Interactive comment on “How do modeling choices impact the representation of structural connectivity and the dynamics of suspended sediment fluxes in distributed soil erosion models?” by Uber et al.

Answer to reviewer #1

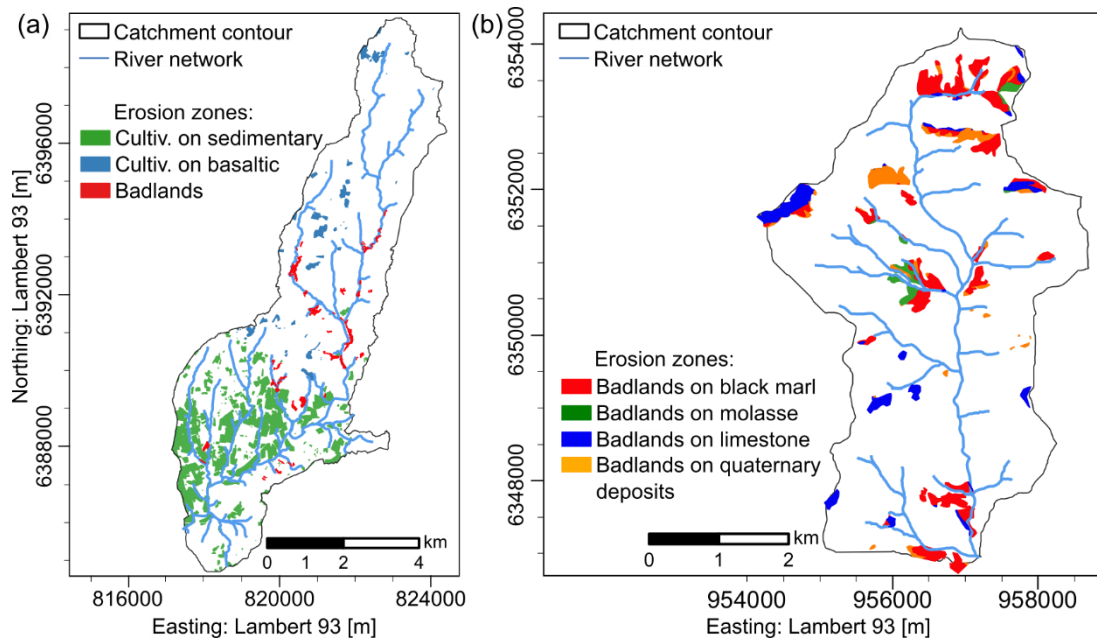
The interactive figures provided by Uber et al. (2020) are a fantastic complement to the paper. I might consider adding catchment as a facet (e.g., facet grid with scenario catchment) because this would facilitate comparison between catchments.

This is a nice idea, but it is not easy to implement. We prefer to keep the interactive figure as they are.
